PROJECT: Skye Canyon 5.01 S 5.03

SUBMITTAL: 1st

CITY OF LAS VEGAS		DATE:
INTER-OFFICE MEMORANDUM		February 8, 2021
TO: Land Development Services Department of Building & Safety		FROM: Jennifer Shinn, P.E. Flood Control, Engr. Associate Department of Public Works
SUBJECT:	Drainage Study for:	
	Skye Canyon 5.01 & 5.03	
Cross Streets:	Shaumber Rd. & Iron Mountain Rd.	
File Number:	F:\Depot\DSMemos\DS5411A.doc	
Parcel Number:	126-12-511-001 & -003	
Zoning Action:		
FEMA Flood Zone	YES	NO X
Proposed Storm Drain	YES X	NO
COPIES TO:		
		Impulse
		RCI Engineering
		Century Communities Nevada, LLC
		Bart Anderson, P.E., DevCo
		CCRFC

The following are comments pertaining to the subject site specific drainage study and grading plans:

D-2

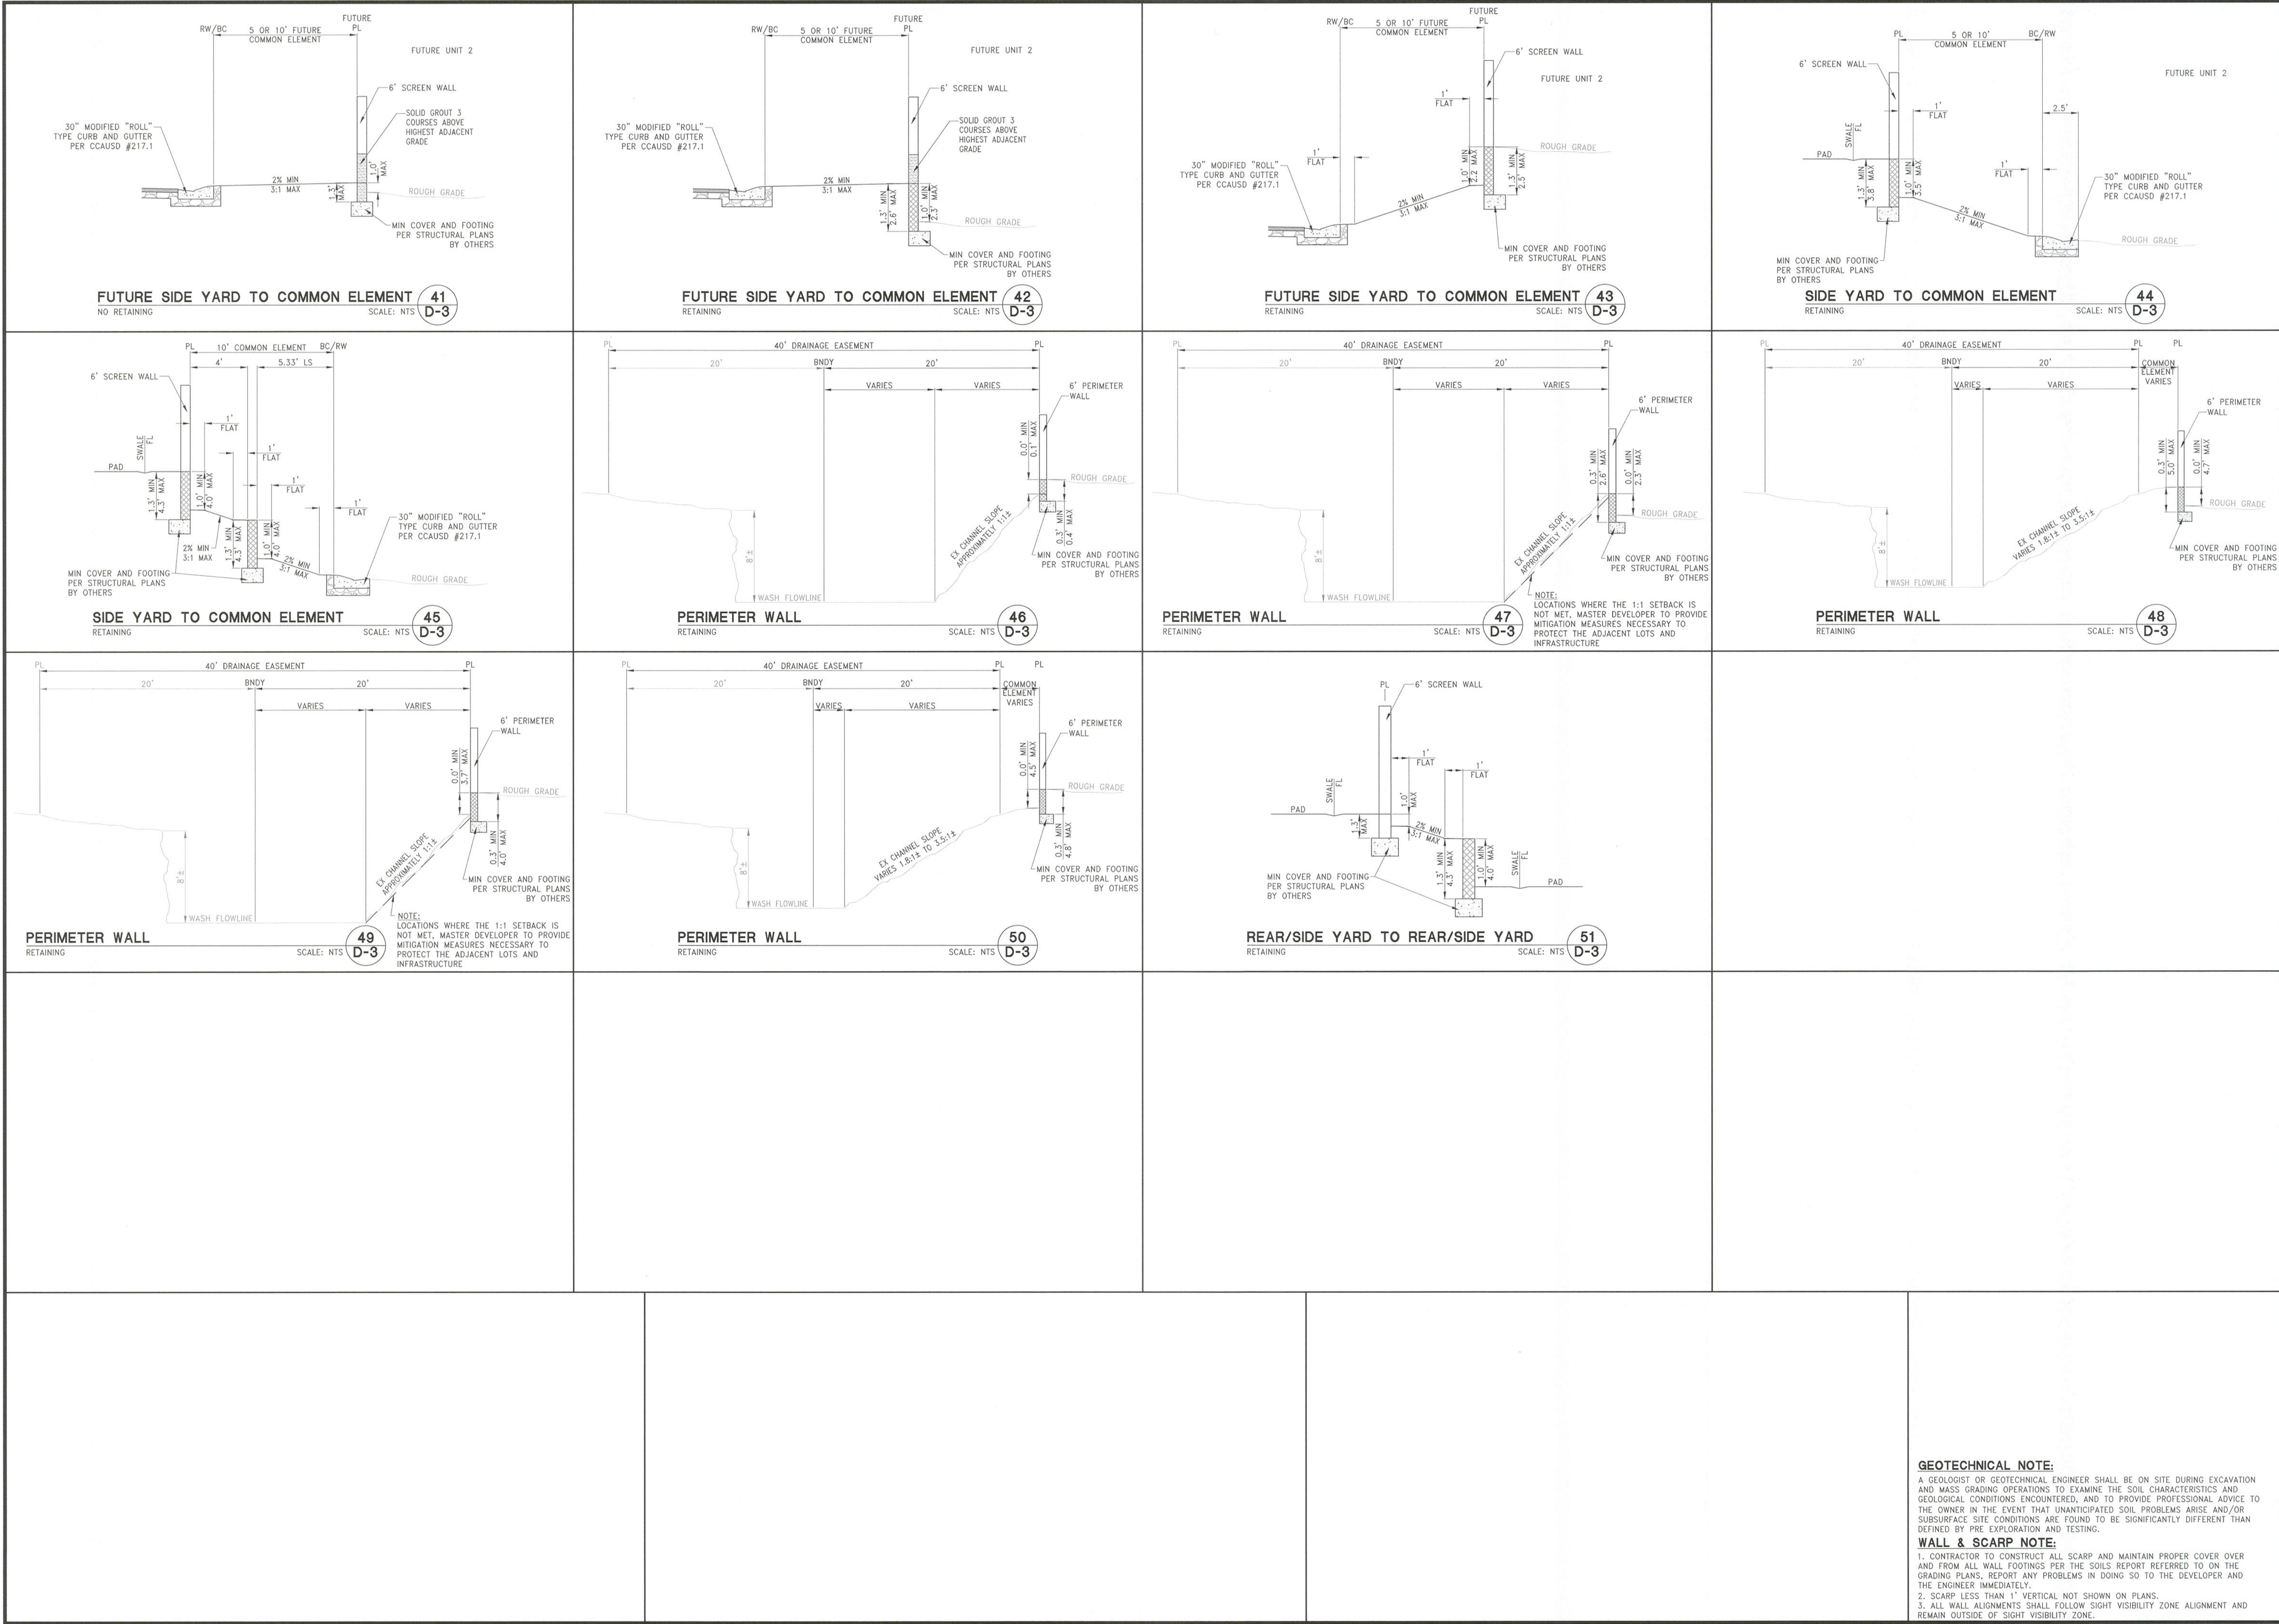
13. Label Section Detail 22/D-2 as a "Public Drainage Easement to be Privately Maintained" and show the dimension of the easement. Note that Public Drainage Easements shall be constructed per CCAUSD 425.S1.

IMPROVEMENT PLANS FOR
SKYE CANYON 5.01 AND 5.03 UNIT 2
A SINGLE FAMILY RESIDENTIAL SUBDIVISION
GRADING PLAN (SHEET 1 OF 3)

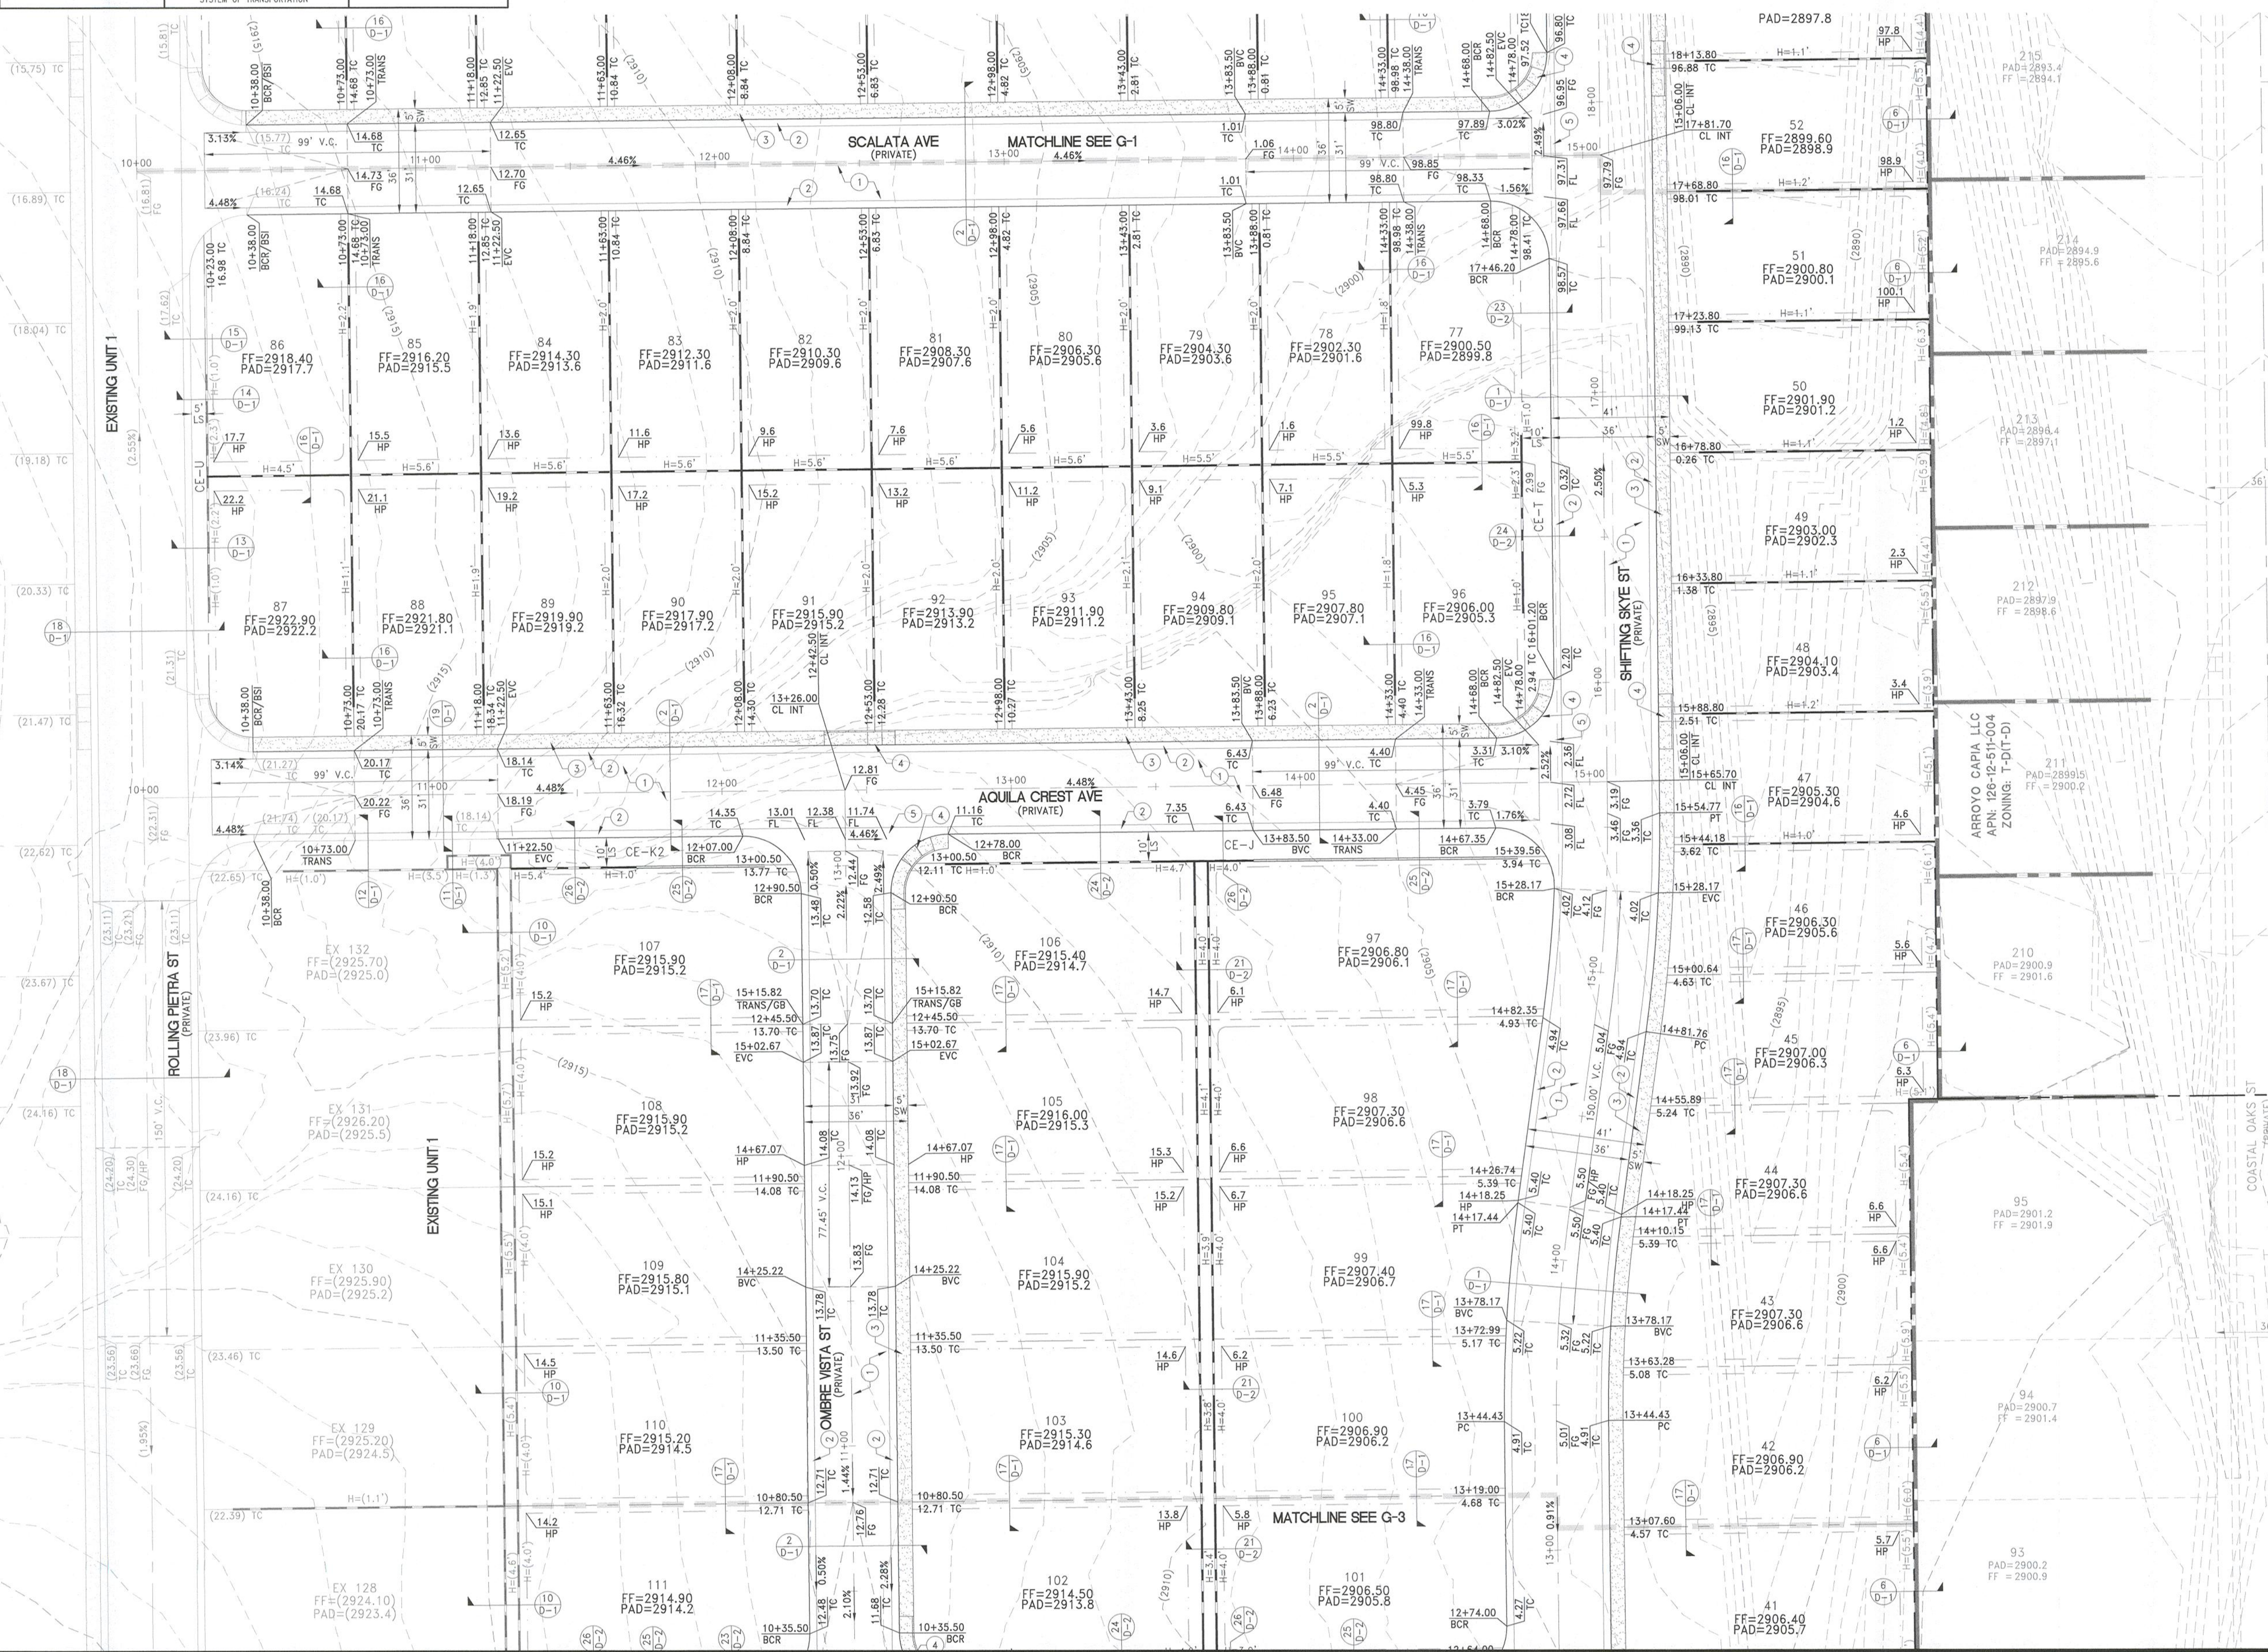
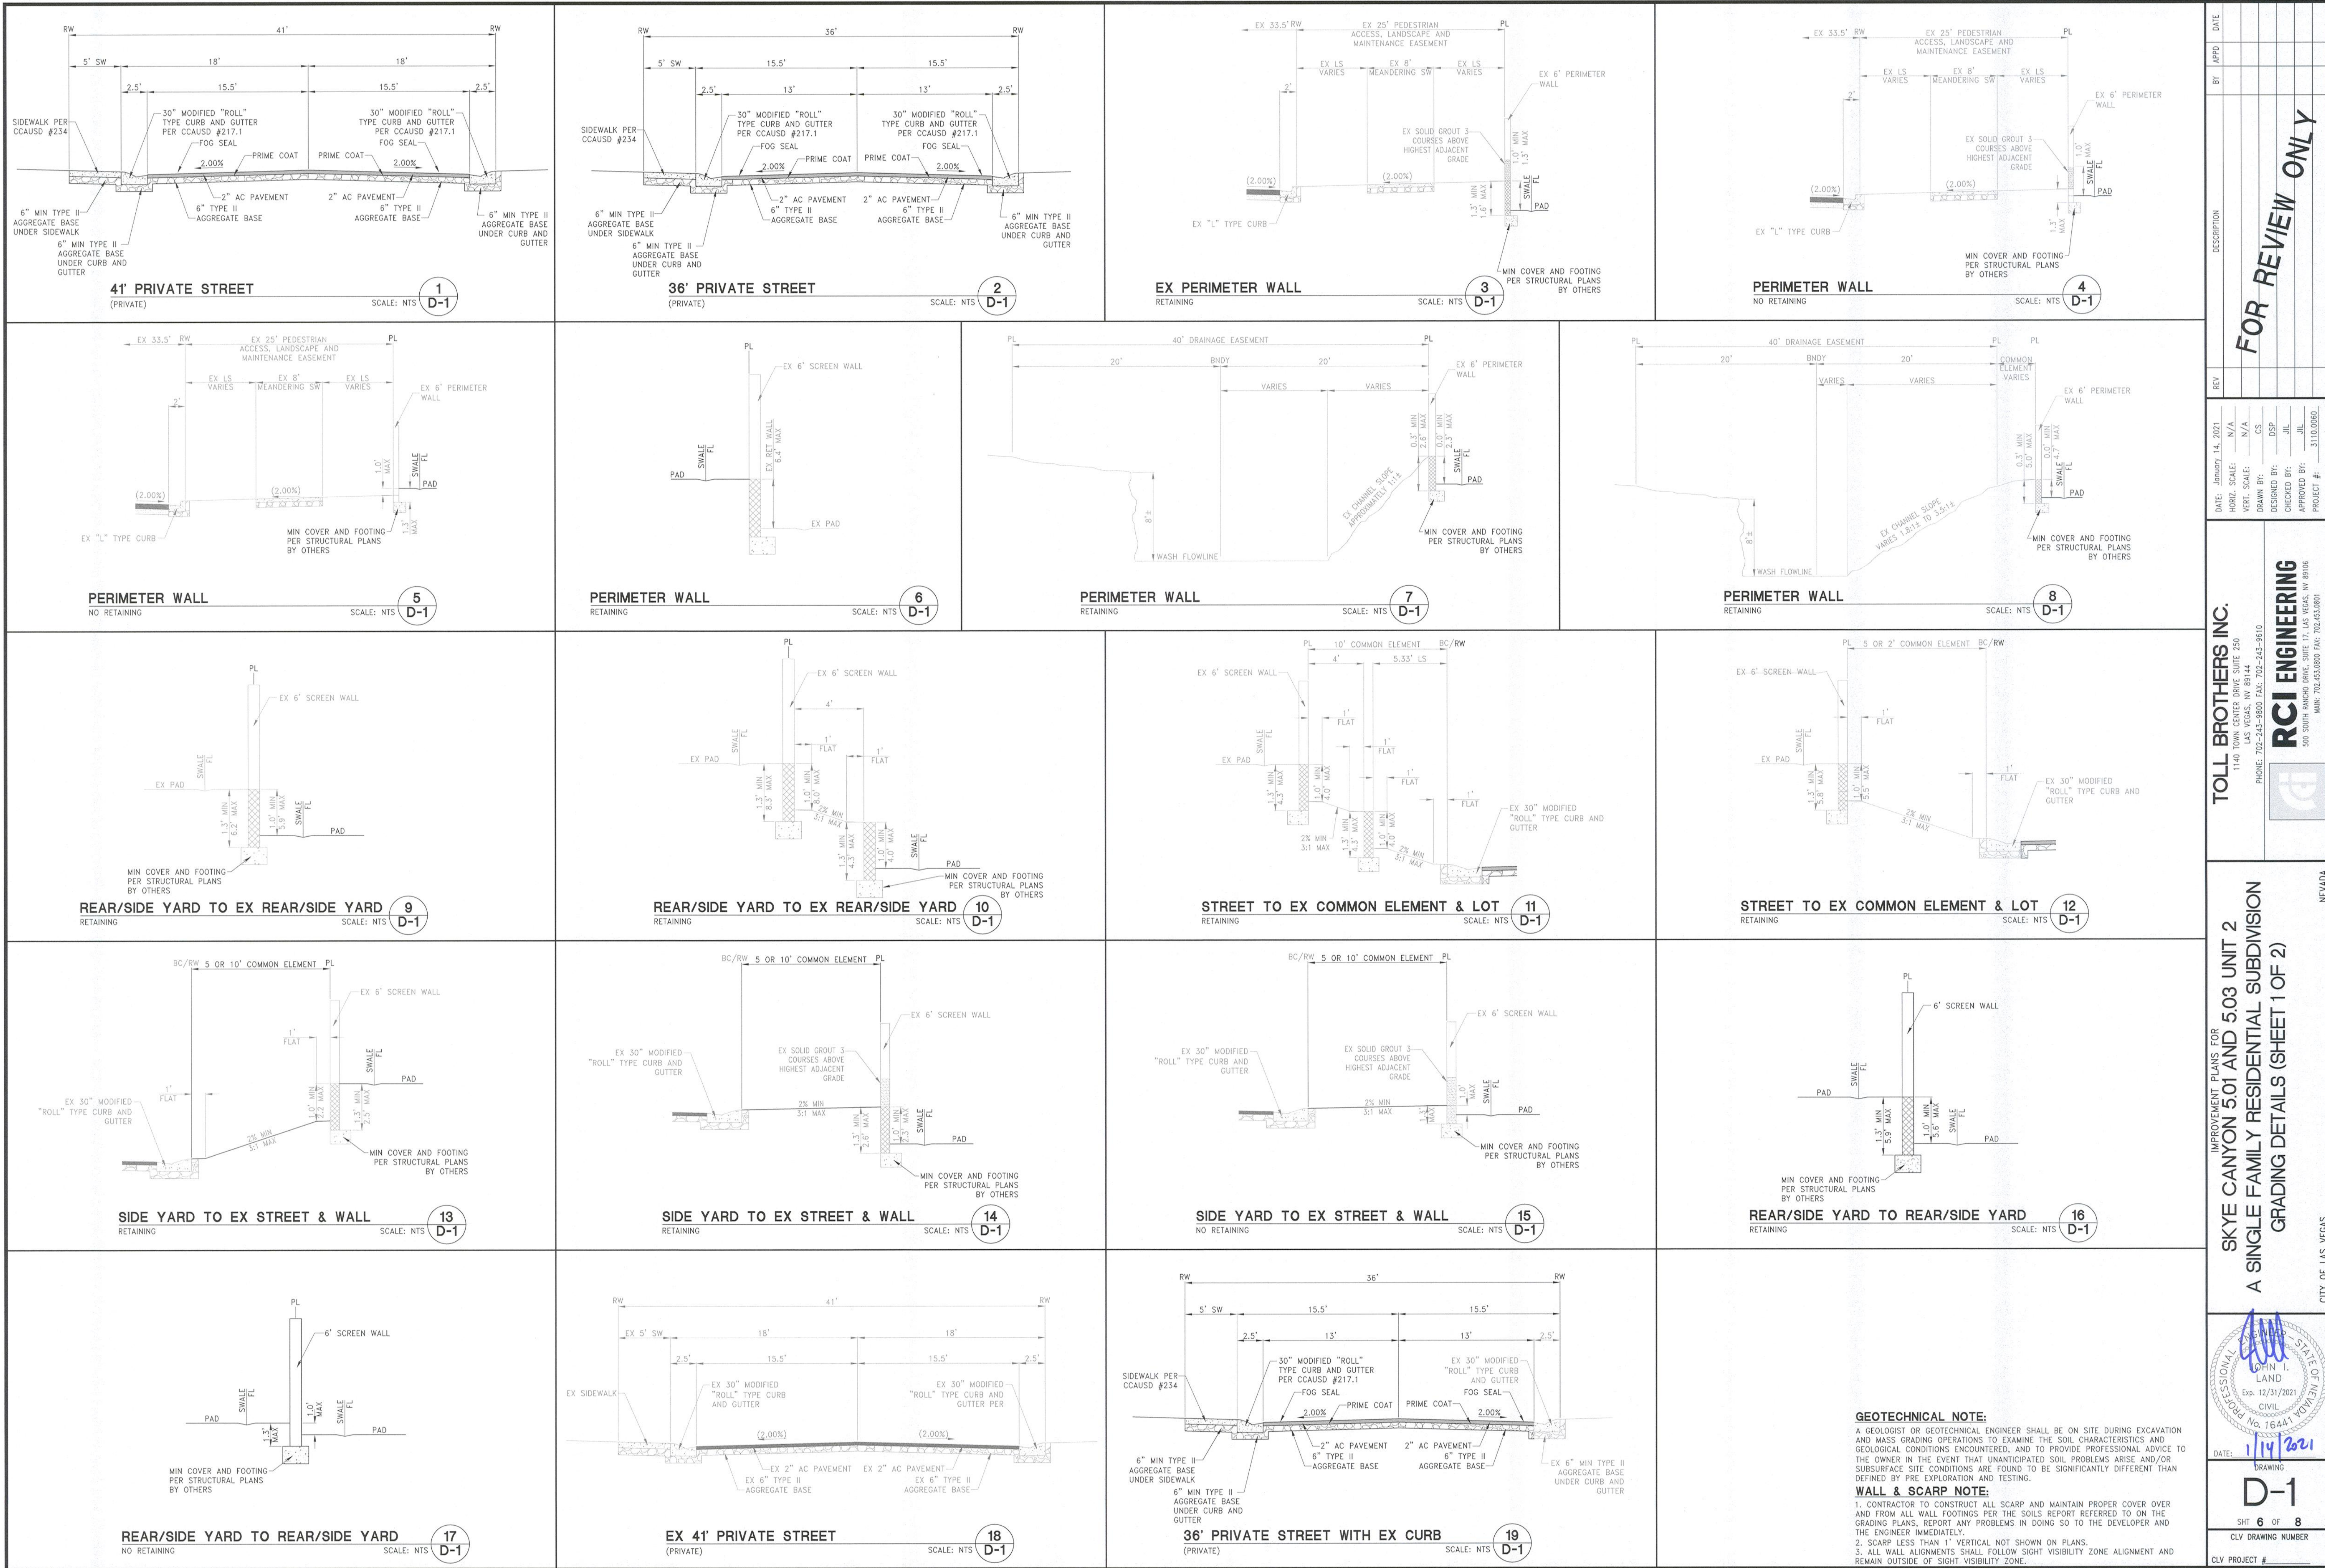
14. Label Iron Mountain Road on the Unit 2 Grading Plans.
